marantz® SERVICE BULLETIN		Date: 30-June-2003	Model: SR4300,SR4400
		Page: 1 / 1	REF.NBR: MZ03-023
Circulation:		Subject:	
Application:		The sound is interrupted, when the playback DIGITAL of CD-R/RW of the SCMS signal.	
x for information customer complaint in case of service mandatory	See Below	Int.ref:

marantz® SERVICE BULLETIN		Date: 31-Oct.-2003	Model: SR4300/SR4400
		Page: 1 / 3	REF.NBR: MZ03-047
Circulation:		Subject:	
Application:		The problem of the Speaker protection circuit.	
x for information customer complaint in case of service mandatory			
		Service code XE00 XE00xxxxxxxxxx

marantz® SERVICE BULLETIN		Date: 30-June-2003	Model: SR4300,SR4400
		Page: 1 / 1	REF.NBR: MZ03-025
Circulation:		Application:	
x for information customer complaint in case of service mandatory		See Below	
		Subject: FM(with RDS) signal is received, Frequency Indication becomes the setup of default by the remote control operation . (only N and A version occurs)	
		Int.ref:

SR4300

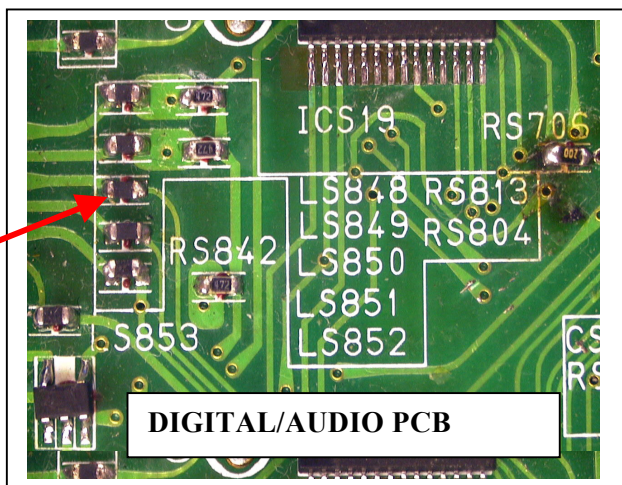
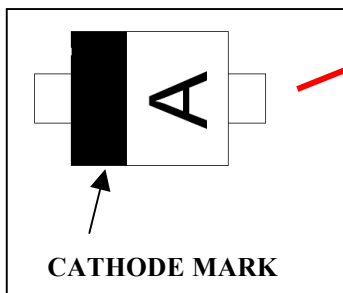
LS850 is changed to
Part no. *HD201810R

Caution
JFS08 (FPC CONNECTOR) side is
CATHODE

- 1) Chip Resistor **LS850** (100 ohm 1/16W part no. NN05101610) is changed to **Silicon Diode (Part no. *HD201810R--- 1SS400 POHM: EMD2, EIAJ: SC-79, JEDEC: SOD-523)**.

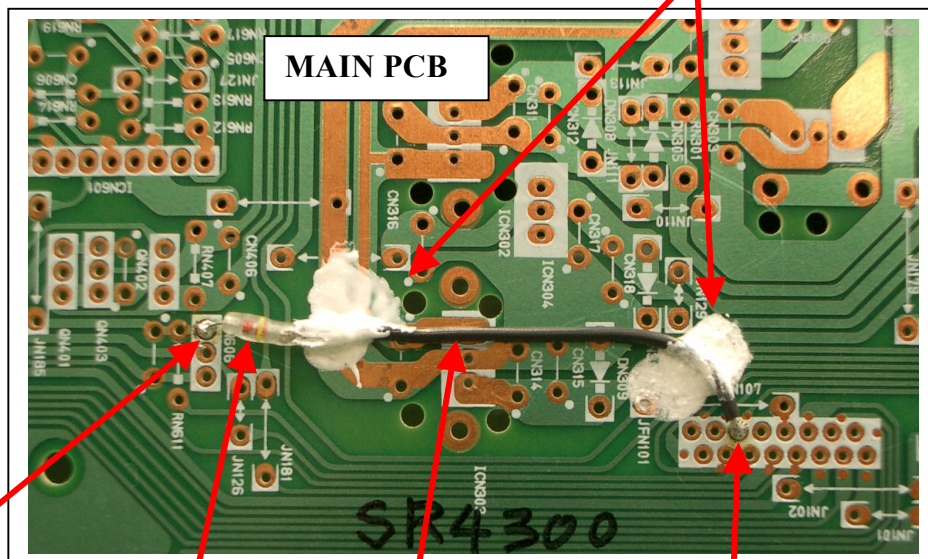
BASE of QN606

DN601
Part no. HD20002000

No.5 pin of JFN101

Insulation tube is used

- 2) Chip Resistor **DN601(Part no.HD20002000---Silicon Diode 1SS254 ROHM)** is added between BASE of QN606 SEMICOM.COMP and No.5 pin of JFN101 Connector

SR4400

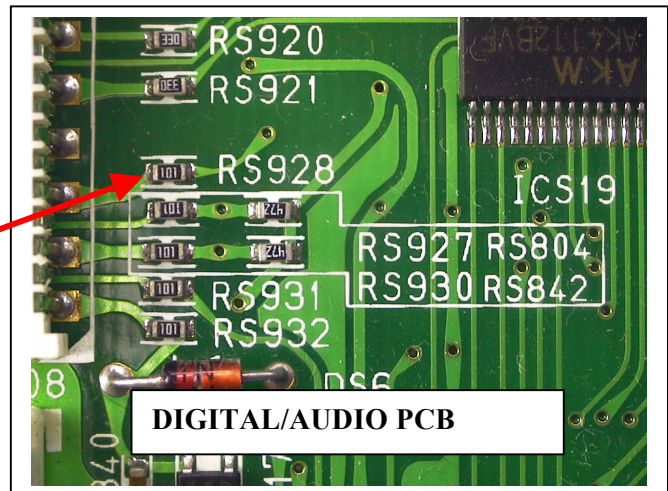
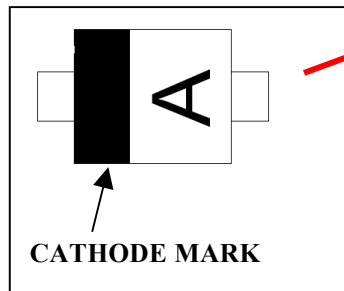
RS928 is changed to
Part no. *HD201810R

Caution
JFS08 (FPC CONNECTOR) side is
CATHODE

- 1) Chip Resistor **RS928** (100 ohm 1/16W part no. NN05101610) is changed to **Silicon Diode (Part no. *HD201810R--- 1SS400 POHM: EMD2, EIAJ: SC-79, JEDEC: SOD-523)**.
